## General Comment

## Trail Specific Comments

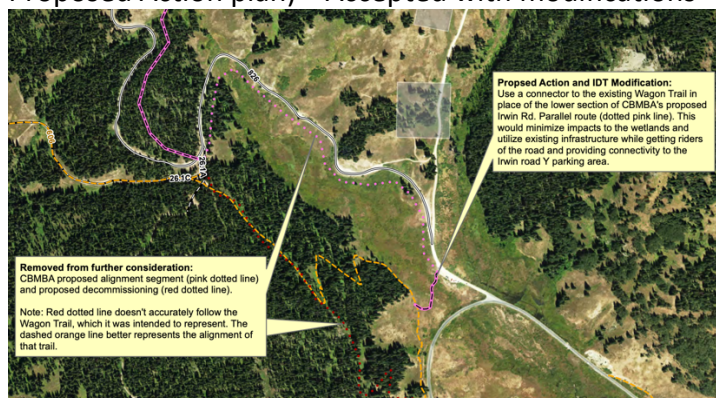
I wish the Forest Service didn't remove trail alignments before the public comment period. For example, how can the Forest Service know that connecting Upper Cement Creek Trail to the Crystal Trail "would not add much (if anything) to the user experience" without making the proposed trail open for comment? I feel like this trail, along with another accepted connector between Lower Cement Creek to the Caves trailhead, would have created one of the best trail experiences in the whole valley. Imagine riding single track from Star Pass to the Caves trailhead.

## 2. Upper Upper to Brush Creek Trailhead

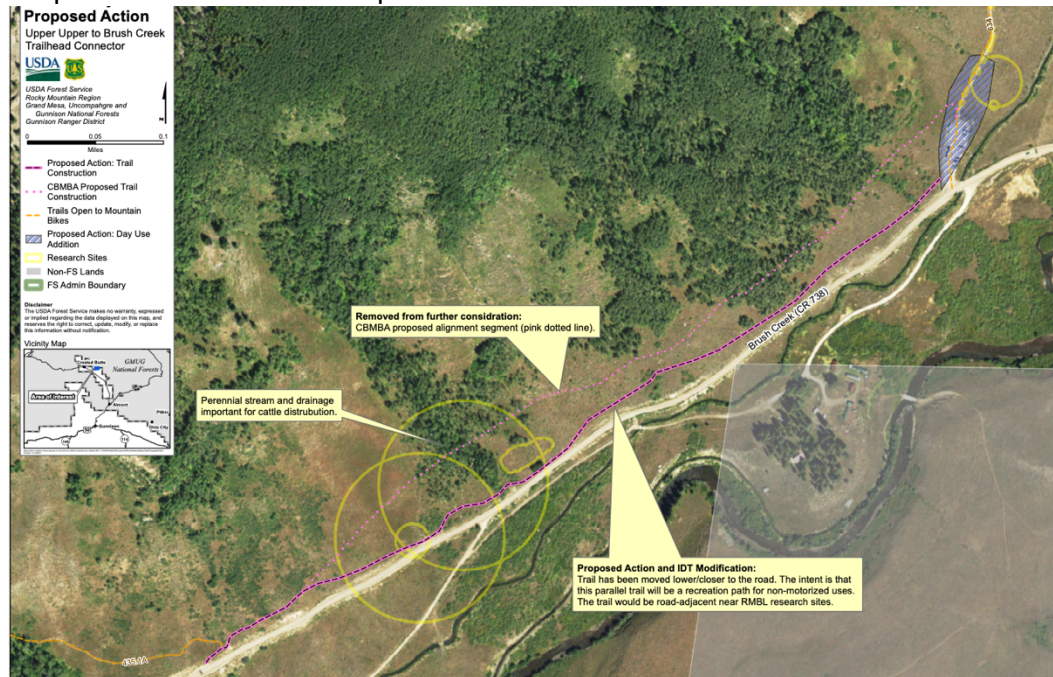
- i. **Comment:** The proposed alignment was removed before the public could comment, and I believe the Proposed Action and IDT Modification is based on faulty assumptions. First, looking at the map, one might assume that the user experience will be equal between the two alignments. It won't be equal. Users want to be separated from the road, not adjacent to it. I believe most users will continue using the road if the modified route is implemented. Second, I don't think I've ever seen a cow on the side of that hill in all my years riding and driving out Brush Creek Road, so I don't understand how the proposed trail adversely affects grazing. Plus, I believe seasonal closures were offered to mitigate grazing disturbances. Third, both trail alignments cross the watershed, so the watershed disturbance assumption appears to be a wash. Fourth, the IDT modified alignment runs right through a RMBL research plot. RMBL is a valued community partner, so it's hard to imagine how this trail gets built if it will negatively impact RMBL. Fifth, I believe both trail alignments run through an existing designated recreation corridor, and it seems like the scales should tip in favor a better recreation experience, especially after conceding so many other trails in the area to ranching interests. If a seasonal is an option, and a trail can be built that will lure users off the road and avoid RMBL's research plot, and the area has already been designated for recreation, I don't understand why the original trail alignment was removed before public comment. This project has

significant potential for separating the non-motorized and motorized users and benefit recreation experiences. I would like to see the original alignment reassessed by the Forest Service and reopened for public comment because I think it meets the Purpose and Need better than the modified action.

3. Strand Bonus to 409

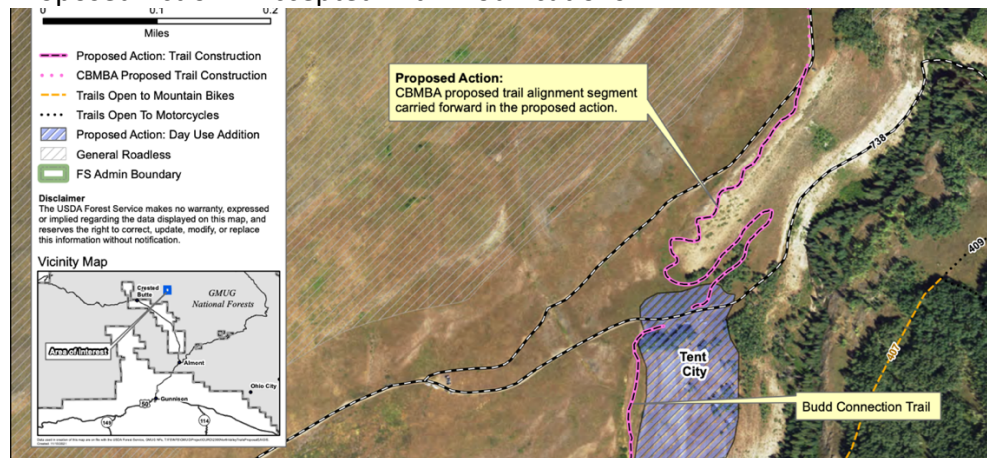
- i. **Comment:** I fully support this proposed trail. It will get lots of use.

## 9. Cement Creek Trail – Lower Cement Creek to Caves

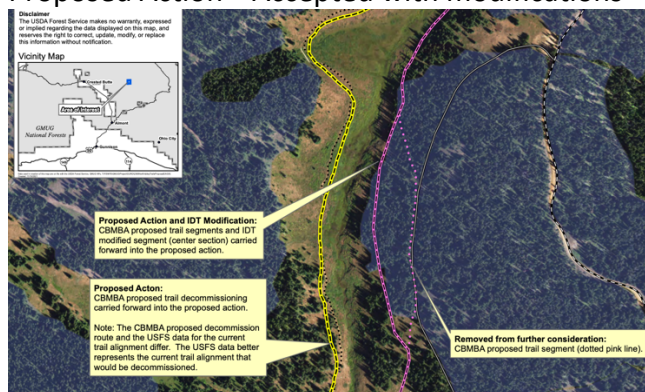
- i. **Comment:** I agree it is a great fit for the Purpose and Need. This one is a no-brainer. It's probably tied with the Upper Upper to Brush Creek Trailhead trail as far as positive impacts go.
